List of Changes

Response to Editors' Comments

Figure 11. Growth rates of I_G and the maximum I_G value across storm events. r_1 and r_2 denote the ascent rates during the first and second peaks, respectively. (Page 20, Line 390)

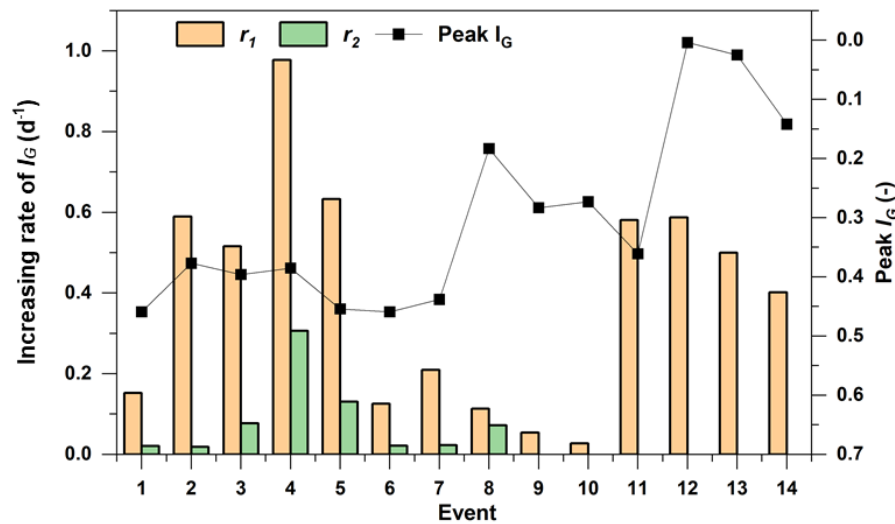
Figure 11. The notation of the measurement units of the principal vertical axis should be corrected (see previous comment).

35. Figure 11: Standardized the vertical axis unit in Figure 11 to d⁻¹ for consistency, in response to Comment 29.
36. Figure 13: updated the x-axis from days to hours.

Thank you for your comment. We have corrected the notation of the measurement units on the principal vertical axis of Figure 11, changing it to d⁻¹ for consistency and accuracy.

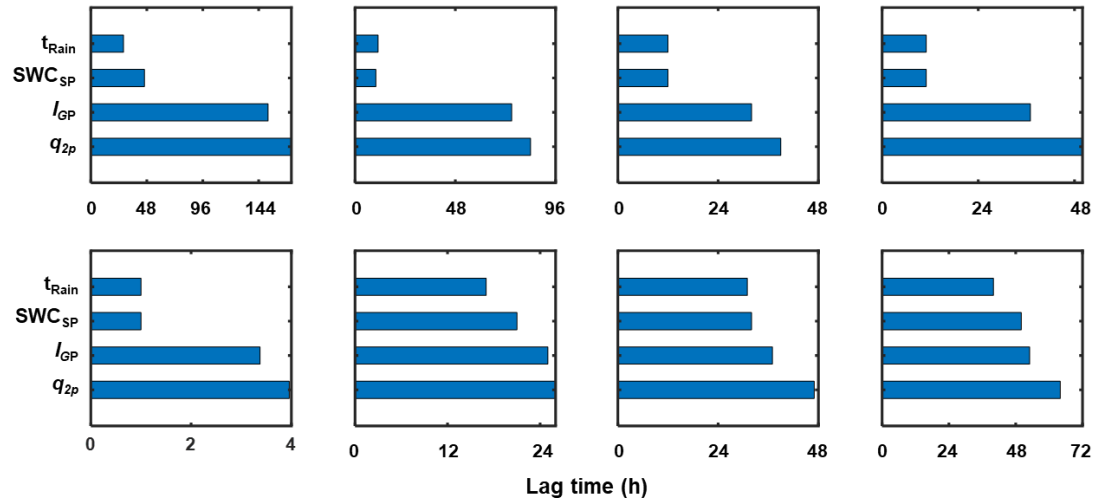
Lines 453 & 455. Isn't it better to give values in hours rather than in days?

Thank you for your suggestion. We have converted the rainfall duration and peak timing values from days to hours for better clarity and consistency. Accordingly, the relevant sentences now state: "Rainfall durations for the analyzed events ranged from 11h to 40 h. SWC, I_G , and delayed stormflow (q_{2p}) followed a clear sequence in their peak timings relative to rainfall onset. SWC responded rapidly, with its peak occurring 10 h to 50 h after rainfall began, usually coinciding with or slightly after rainfall cessation." (Page 24, Lines 477 & 479)

Additionally, we have updated the x-axis of Figure 13 from days to hours to maintain consistency.
